Relation between Average Power (AVP) and Optical Modulation Amplitude (OMA)

Comment on Subclause 91.4.1, page 26, Line 4-31

Figure 91-5—Relaxed PR-D type PMD specifications

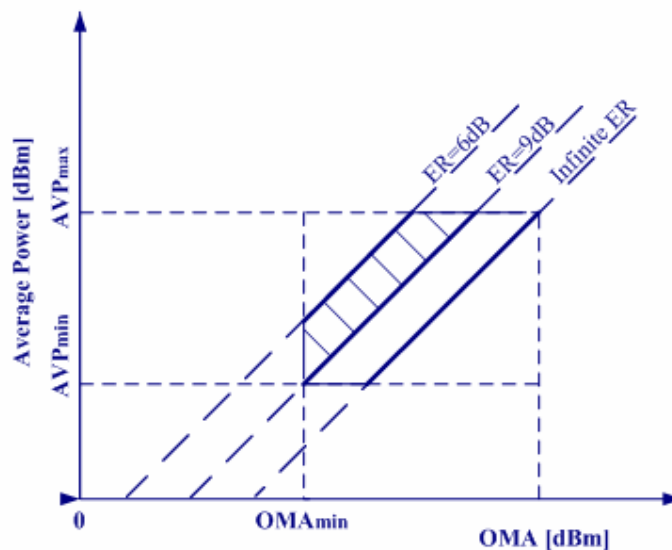
Hence, Figure 91-5 is incorrect. The correct figure should be as below:

“illustrated in Figure 91-5 for a compliant transmitter. Note that the OMA_{min} and AVE_{min} are calculated for the ER=9dB. The transmitter specifications are further relaxed by allowing lower ER=6dB while maintaining the OAM_{min} and AVE_{min} constant. Shaded area indicates compliant part.”

Question are:

- 1) Term "AVE_{min}" seems undefined;
- 2) Figure 91-5 is incorrect;
- 3) There is no shaded area in Figure 91-5.

Propose to change the text above into "illustrated in Figure 91-5 for a compliant transmitter. Note that the OMA_{min} and AVP_{min} are calculated for ER=9dB. The transmitter specifications are further relaxed by allowing lower ER=6dB while maintaining the OAM_{min} and AVP_{min} constant, where AVP_{min} represents the Average launch power (min) as in Table 91-5. Shaded area in Figure 91-5 indicates the compliant part".

Figure 91-5 is changed as shown above.
